3.3 COMMUNITY GROUPS, PRIVATE COMPANIES, AND PRIVATE ORGANIZATIONS COMMENTS AND RESPONSES

Sycamore-Peñasquitos 230-kV Transmission Line Project Comment Form

RE: San Diego Gas & Electric Sycamore-Peñasquitos 230 Kilovolt Transmission Line Project

Figure 5.4-1 Cumulative Projects near Project Alternatives (Revised)

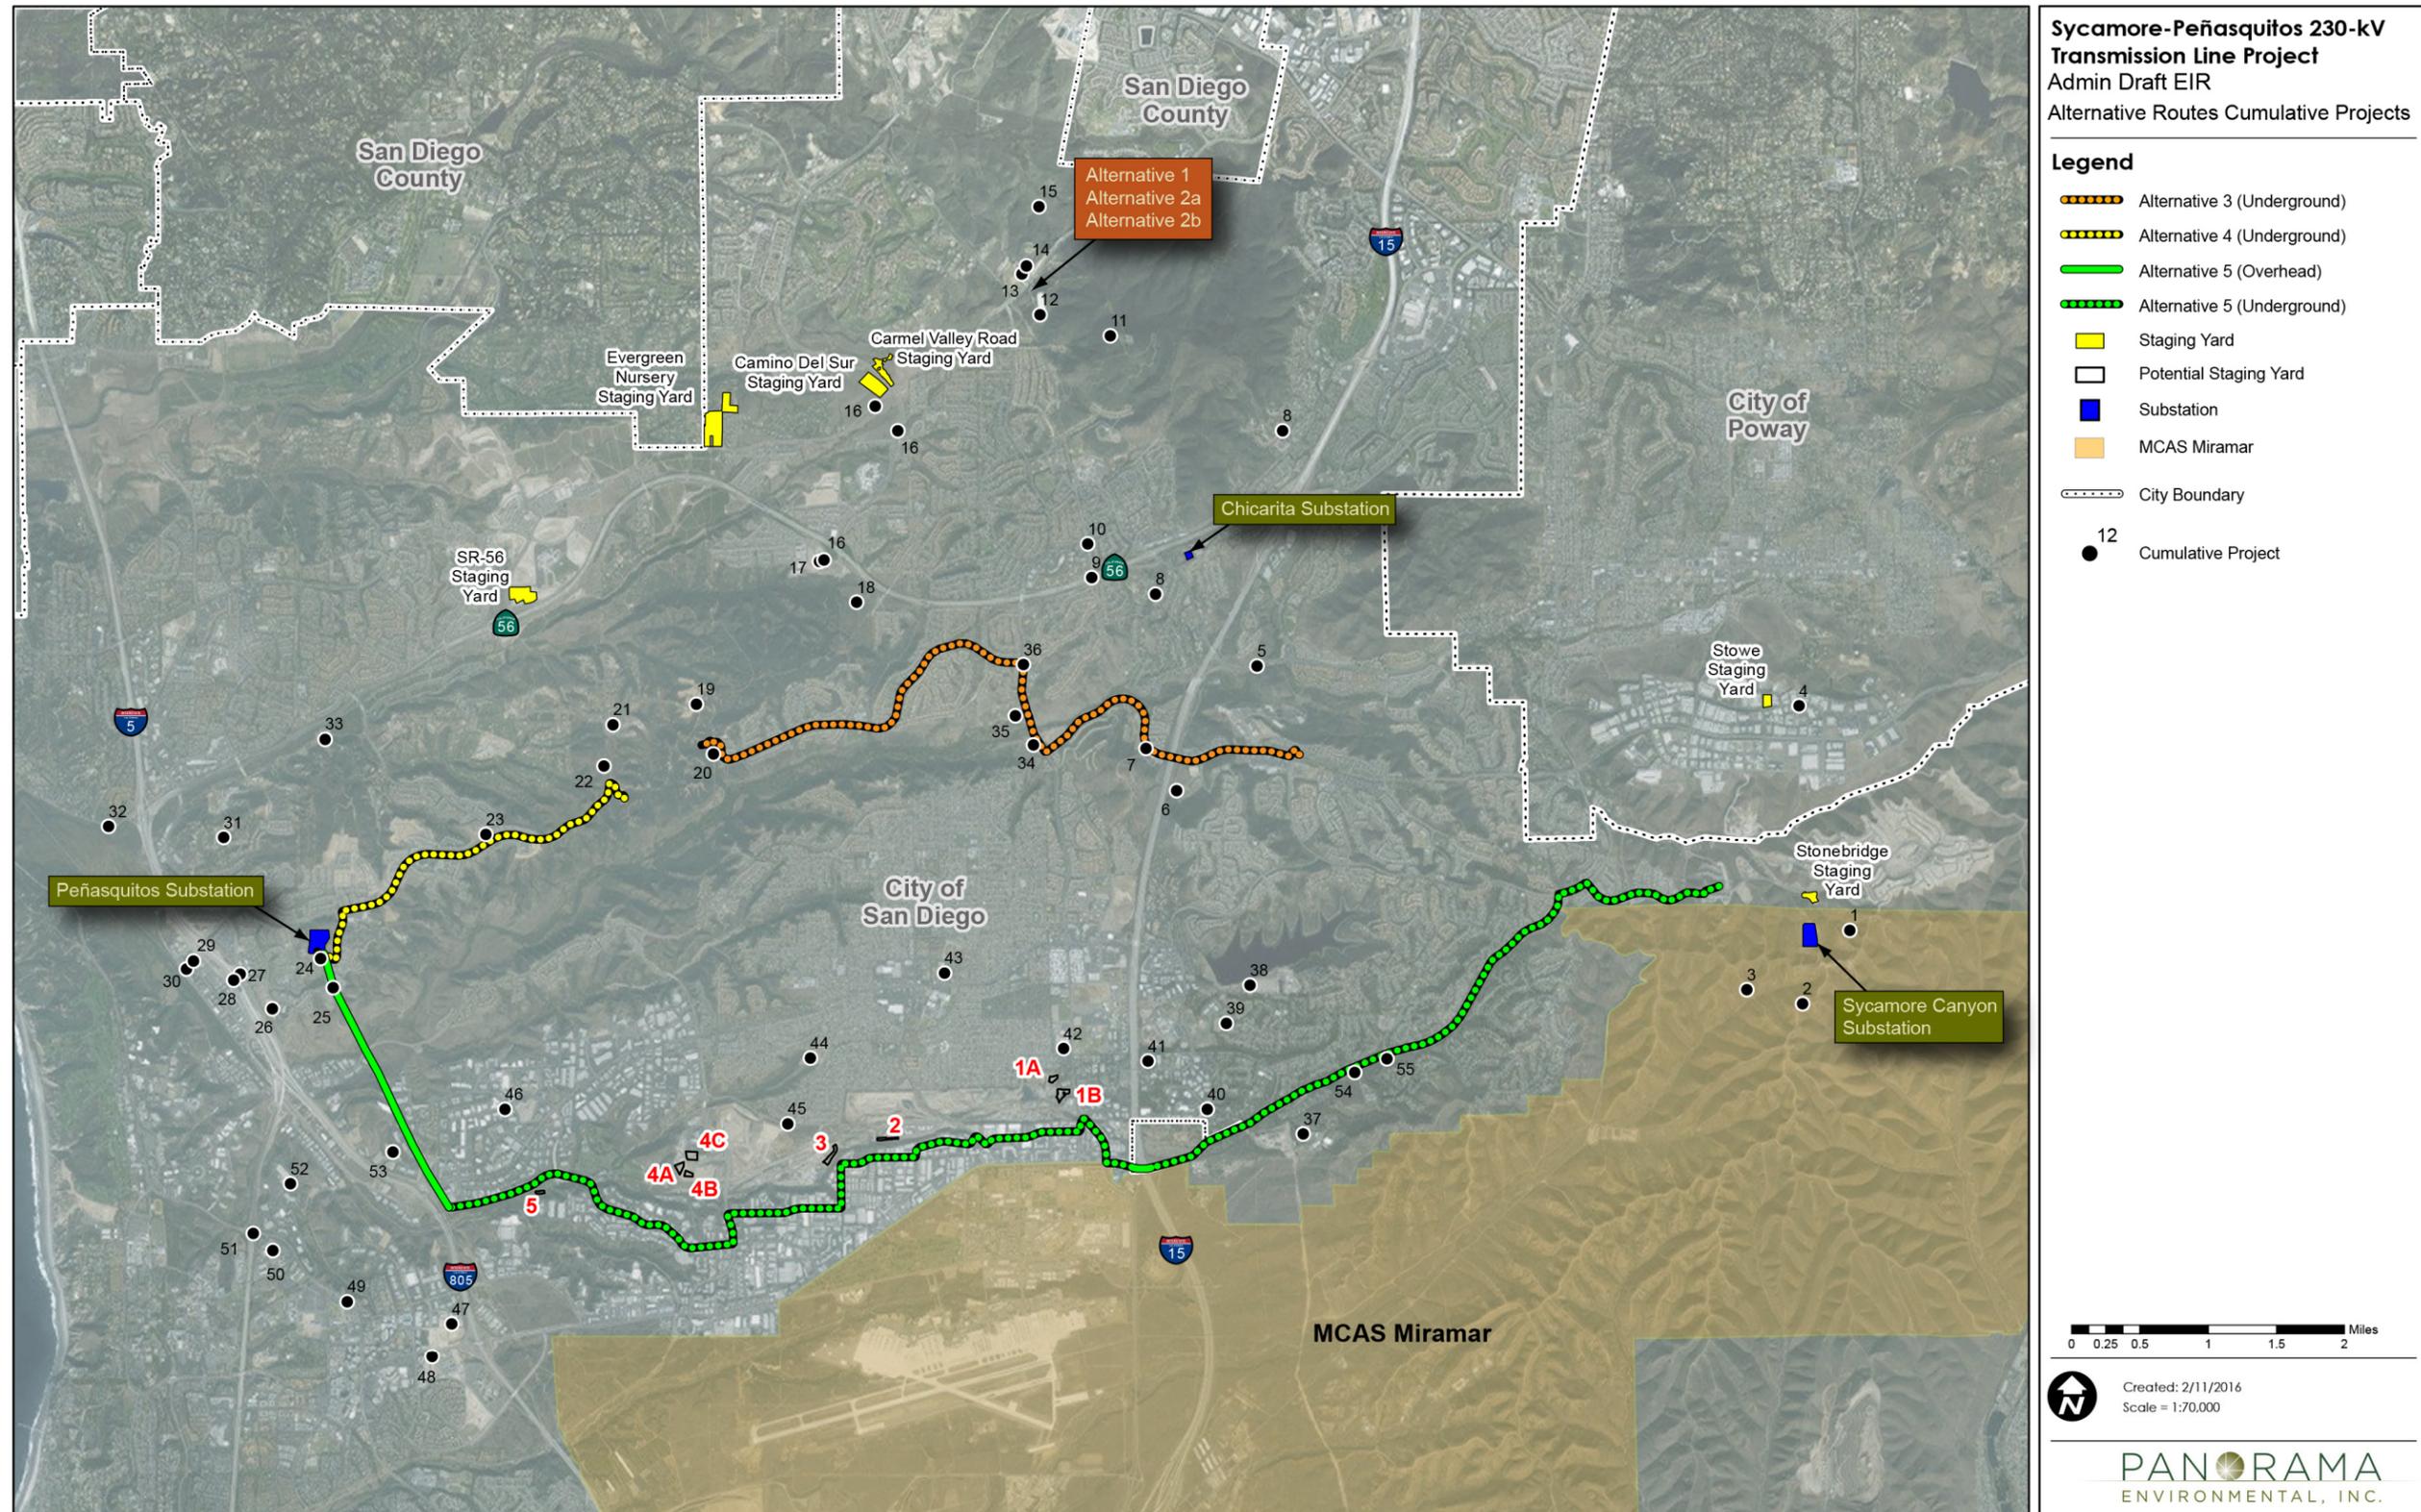
Table 5.4.1 omits at least the following approved and planned projects:

Fire Station 37 Annex at Pomerado Road and Avenida Magnifica. Construction is planned in 2017.

- B7-30 Cumulative projects were identified within an approximately one-mile radius around alternative alignments similar to the Proposed Project, as discussed under Section 5.2.1 of the Draft EIR. Additional projects outside of this radius were also considered if they were determined to be relevant to the geographic scope of a particular environmental resource topic (e.g., air quality, traffic). See response to comment B2-2 for information regarding the SDG&E PSRP. Revisions to the description of the Carroll Canyon Community Center and the addition of Chabad Scripps Ranch Campus of Life expansion and the Fire Station 37 Annex to Table 5.4-1 are presented below. Figure 5.4-1 has also been revised to include the two additional cumulative projects. The revision to the existing project and addition of the two new projects do not change the cumulative impact analysis as the Alternative 5 contribution to cumulative impacts was already considered considerable for aesthetics, air quality, traffic, and noise. The alternative's contribution to cumulative impacts for the other resources areas would remain less than considerable with mitigation or less than considerable, as described in Chapter 5: Cumulative Impacts of the Draft EIR.
